U.S. NUCLEAR REGULATORY COMMISSION
 In the Matter of AmerGen Energy Co. LLC
 Docket No. 50-029-42 Official Exhibit No. Exh. 39
 OFFERED by: Applicant/ AmerGen
 NRC: _____
 IDENTIFIED on 9/14/07 _____
 Action Taken: ADMITTED REJECTED WITHDRAWN
 Reported/Class: Kaufman, TX 75142 DW

Memorandum

**Subject: Further Discussion of the Nature of the Corroded Surfaces and
The Residual Wall Thickness of the Oyster Creek Dry Well**

Iso Wall Thickness Lines for the Internal UT Measurements
in Bay Location 13A

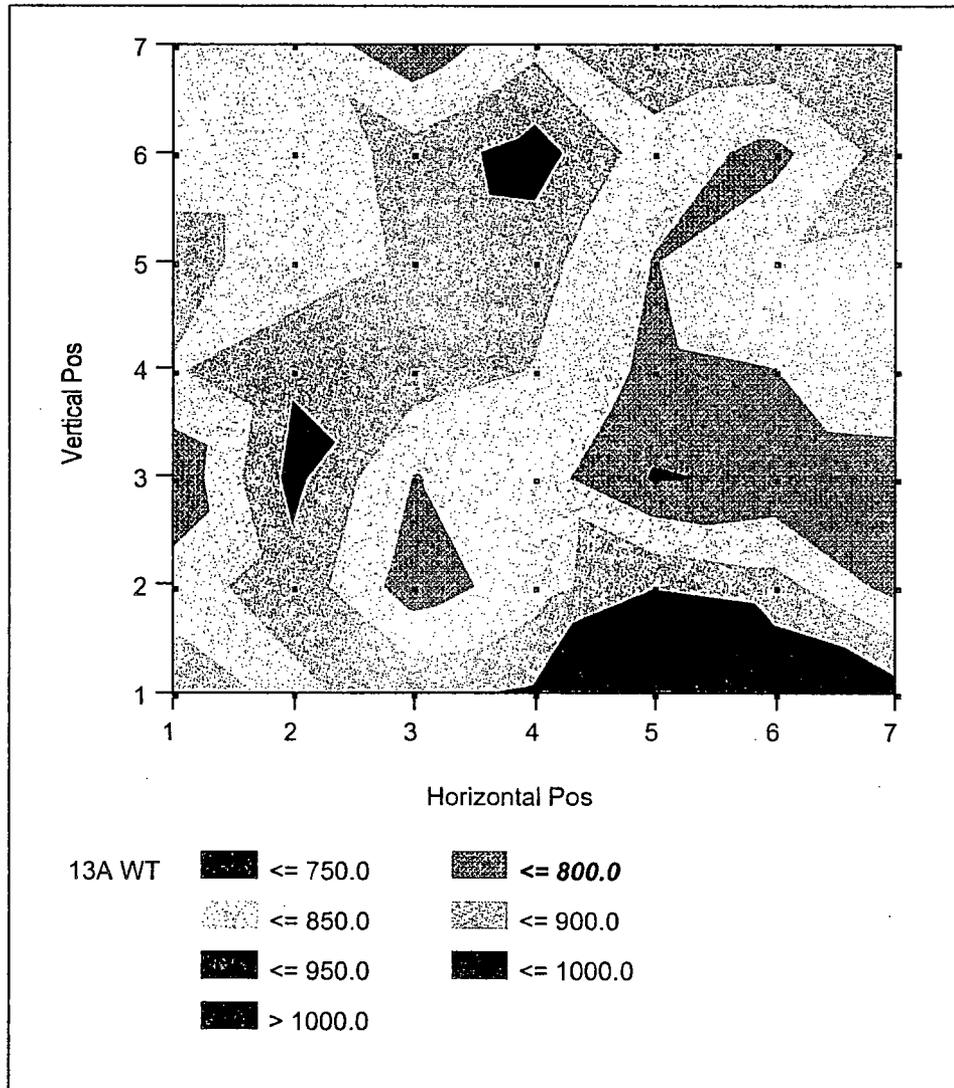
- That because of the location of the internal grid measurements they are not representative of the overall corrosion damage (as discussed above). This is demonstrated by way of an example in Figures 1 and 2 for Bay 13.
- That for Bay 1, where only a strip grid was used for internal UT measurements (1 inch by 7 inch for only 7 UT locations), the results returned by the internal measurements in no way reflect the overall corrosion in that Bay²⁵⁾
- That therefore the external UT measurements have to be used for the assessment of the severity of corrosion and the residual margins.

Schematic Presentation of Drywell External Surface – State of Corrosion

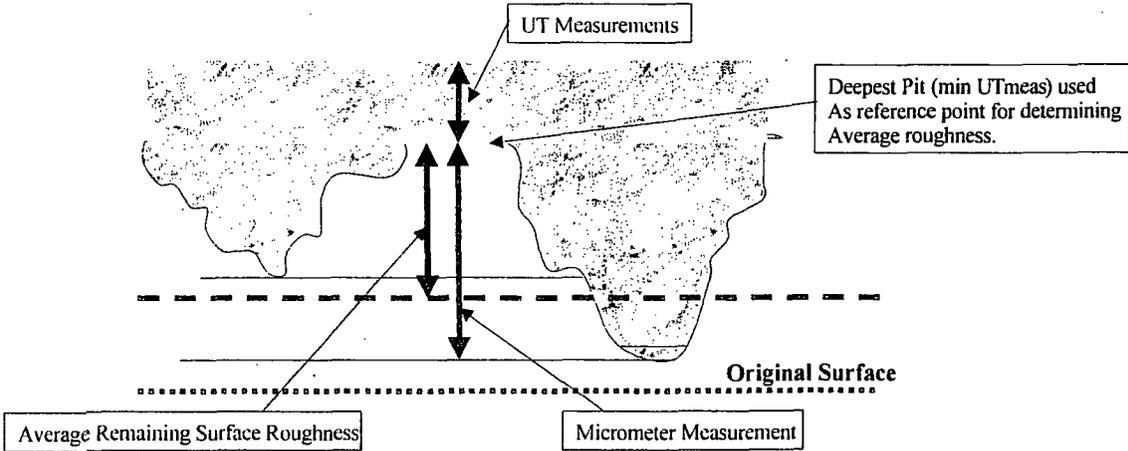
- **Figure 5** shows how the average roughness correction is being used to correct the UT measurements. The UT measurements reflect the residual wall thickness (UT). Additionally micrometer measurements were made at each location where a UT measurement had been performed. Now the UT result and the micrometer result are added and the average roughness is subtracted from the sum in order to obtain the so called “*evaluation thickness*”. It is observed that with this correction every UT measurement, except for one, which had been below 736 mil is moved to above 736 mils and therefore into the acceptable range.

- In discussing this procedure one has to remember that the correction was made because the UT measurement was said to be inaccurate because of the air gap between the probe and the metal surface caused by the inherent roughness. Now it was never established to what extent the accuracy of the UT measurement suffered because of this air gap. Did it over- or underestimate the remaining wall thickness? Similarly, the micrometer measurement is affected by the roughness of the remaining surface as well.

- This entire procedure is extremely fraught with uncertainties. There is the perceived uncertainty of the UT measurement, never established but postulated. There is the uncertainty of the micrometer measurements, and then there is the correction for which there does not seem to be a justification.

- Therefore, the evaluation thickness should be disregarded (as has been done at times) in favor of the actual measurements.
